TUNITAS CREEK BEACH IMPROVEMENTS PROJECT

**COUNTY PROJECT NO. P30T1
PROJECT FILE NO. E4995**

ADDENDUM NO. 1

The following **Addendum No. 1** to the above referenced project, dated April 21, 2023, shall be included in the project specifications and plans.

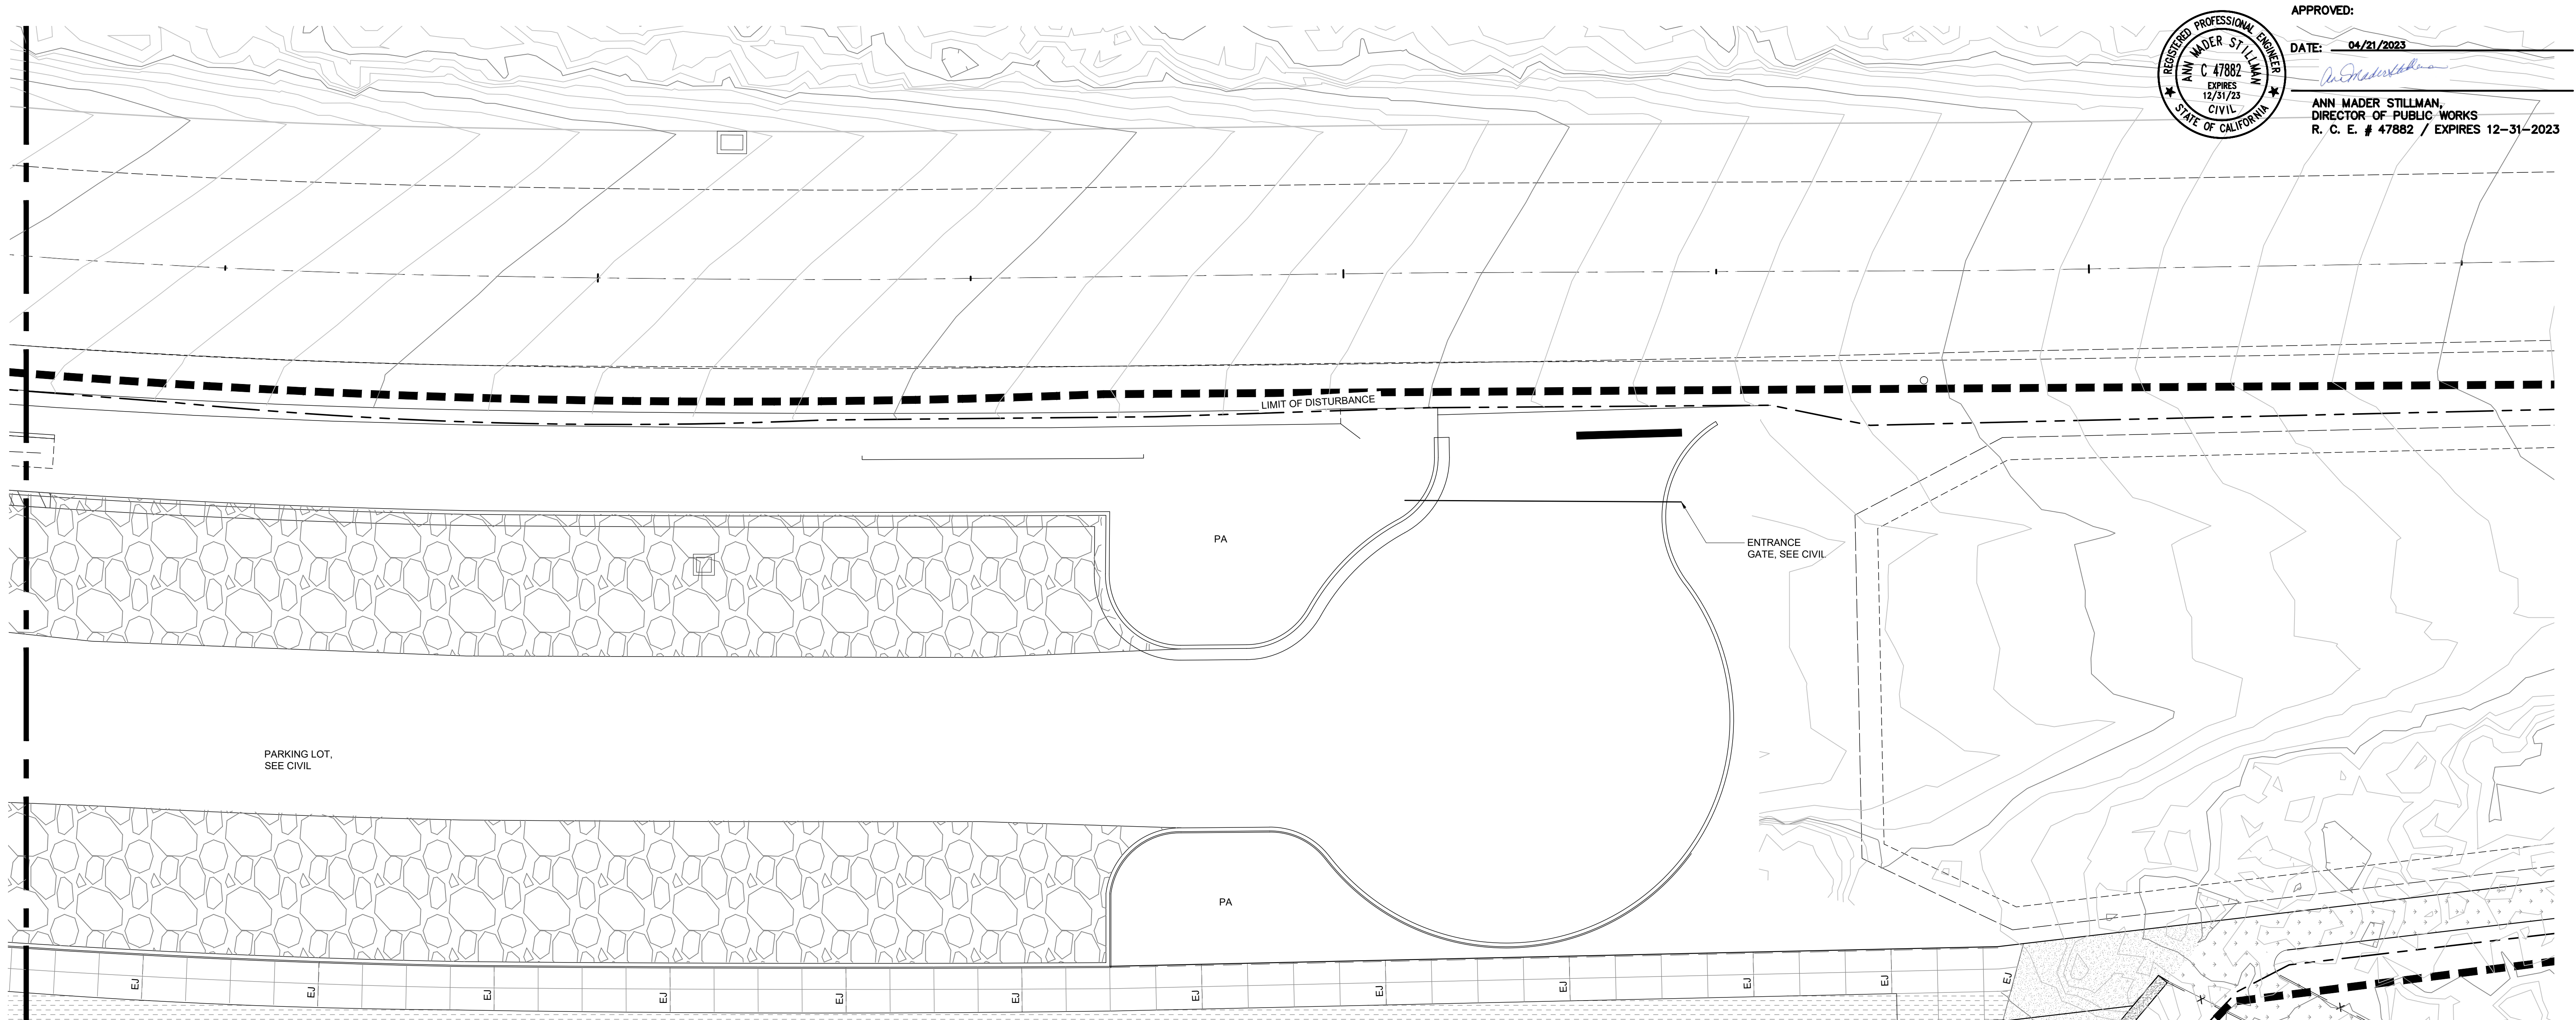
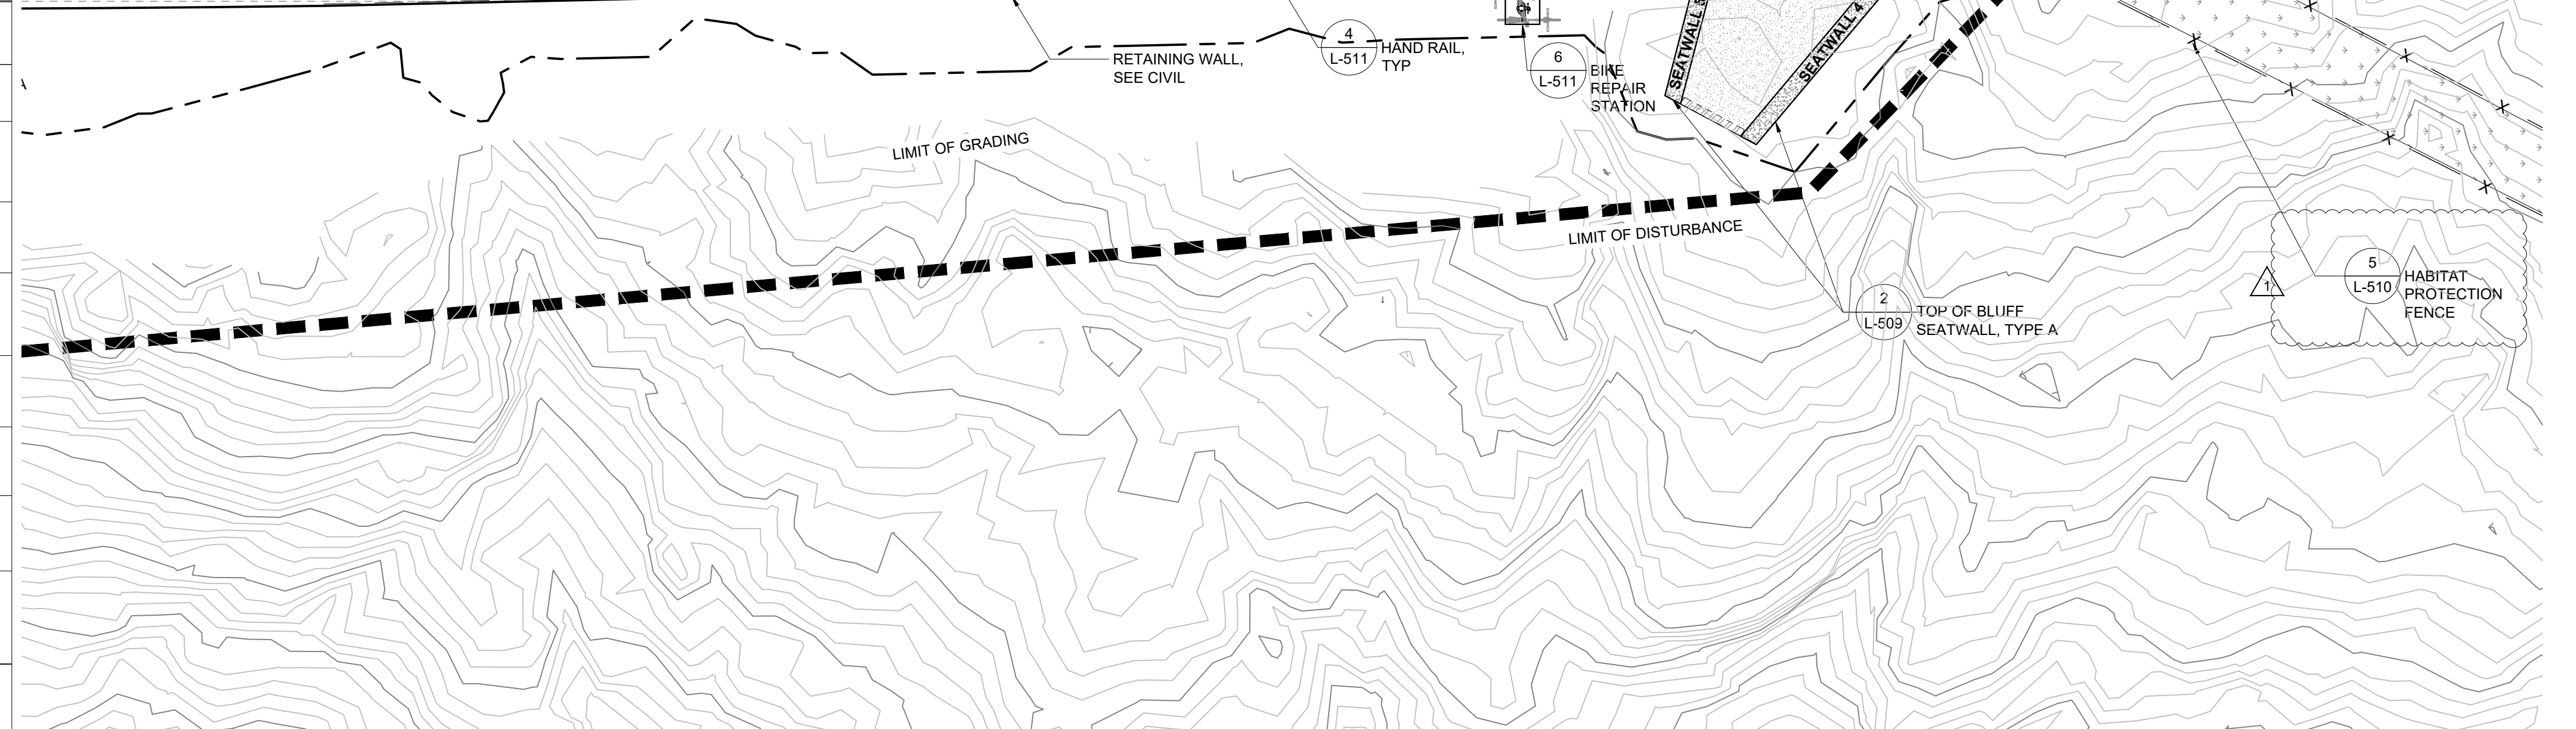
15. The reference to the Habitat Protection Fence has been corrected on Sheet L-118. Plan Sheet L-118 shall be replaced in the Project Plans:

Replace Plan Sheet L-118 (Sheet 74 of 124) with Sheet L-118 (rev) (Sheet 74 of 124).

1 PEDESTRIAN STAIR HANDRAIL SECTION
 SCALE: 3/4"=1'-0"

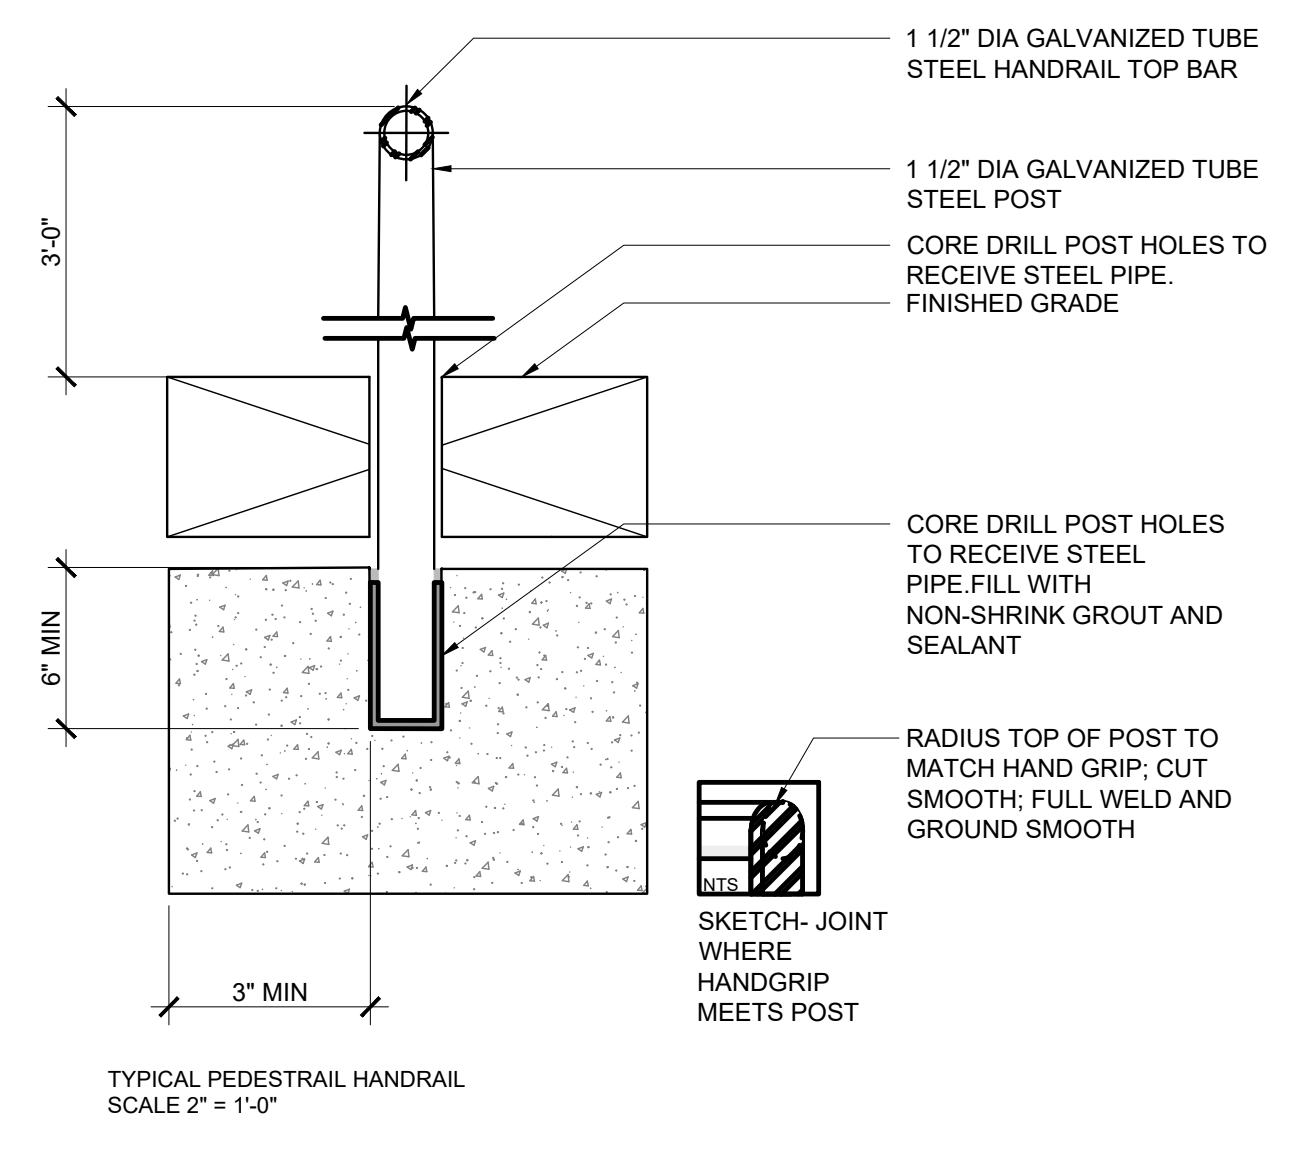
16. Details 1, 3 and 4 for the pedestrian path stairs have been updated on Sheet L-508. Plan Sheet L-508 shall be replaced in the Project Plans:

Replace Plan Sheet L-508 (Sheet 95 of 124) with Sheet L-508 (rev) (Sheet 95 of 124).

1 SINGLE LINE DIAGRAM
 NO SCALE

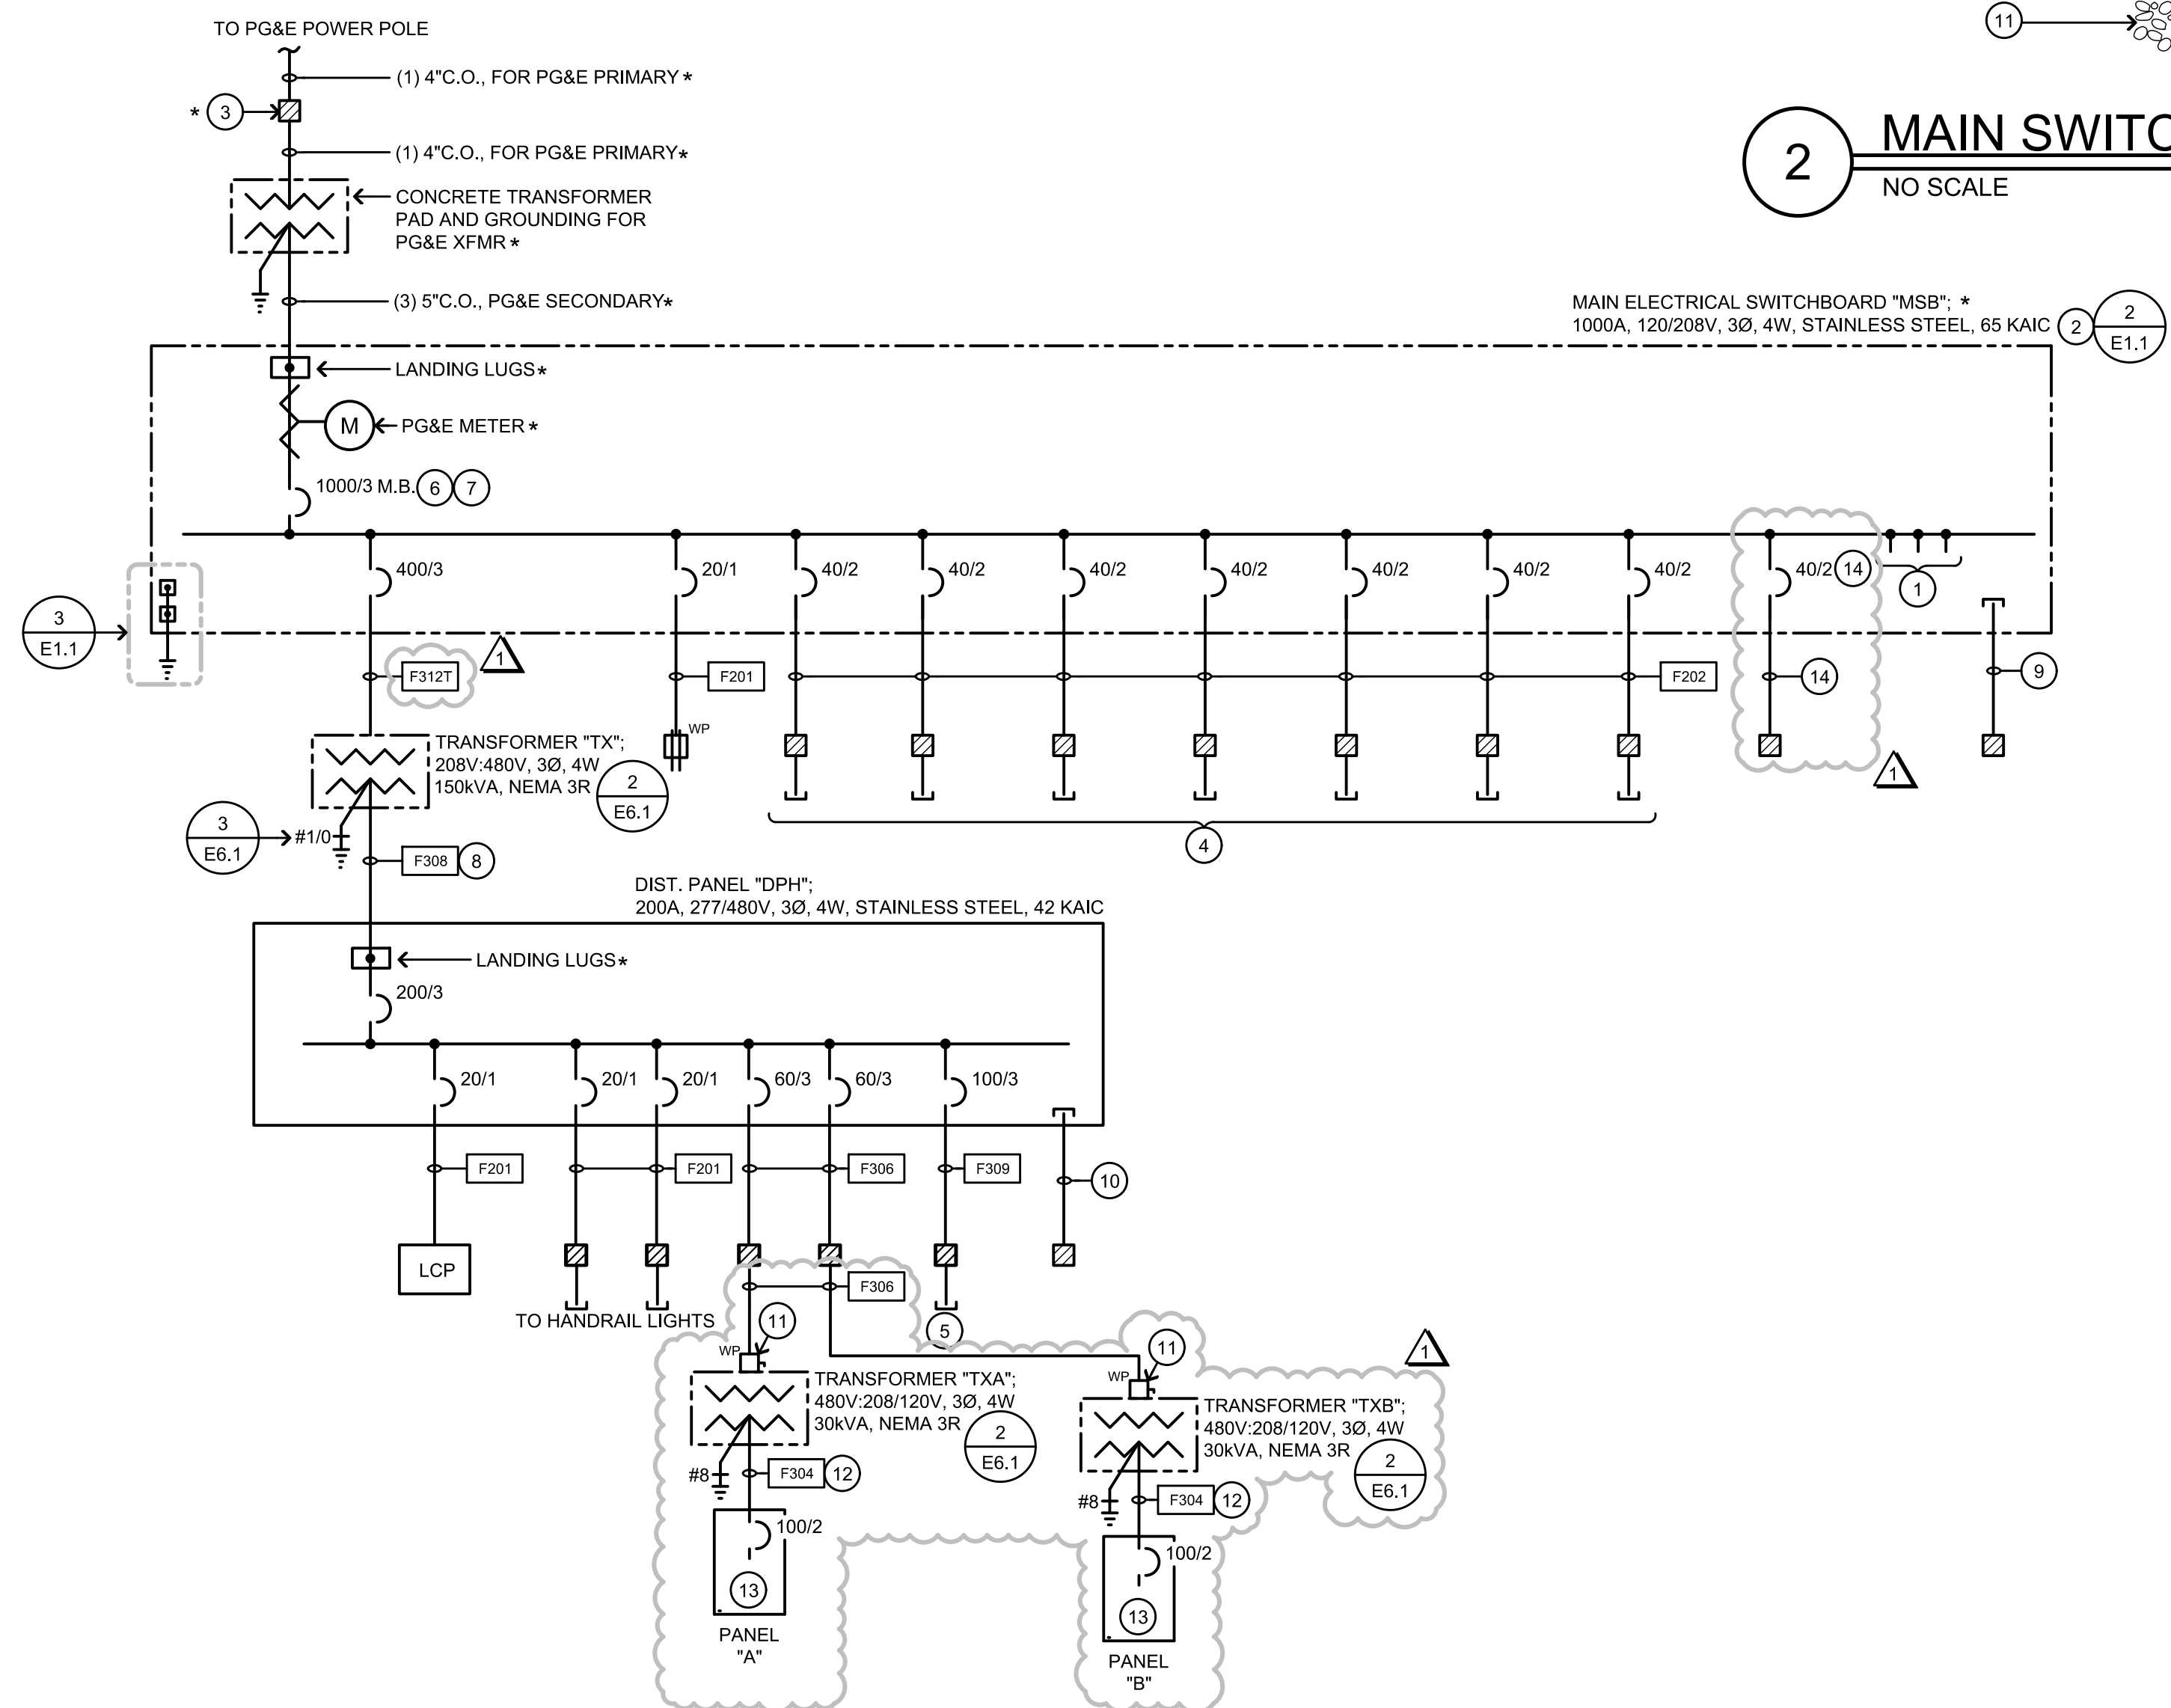
17. The Detail Notes 11-14, Detail 1 Single Line Diagram, and Feeder Schedule has been updated on Sheet E1.1. Plan Sheet E1.1 shall be replaced in the Project Plans:

Replace Plan Sheet E1.1 (Sheet 104 of 124) with Sheet E1.1 (rev) (Sheet 104 of 124).

- PROVIDE AND INSTALL 2" SPARE CONDUIT ONLY AND BOXES FOR FUTURE EV CHARGING STATIONS. TOTAL OF (6). NOT ALL BREAKERS SHOWN FOR CLARITY. SEE E2.2 FOR LOCATION.
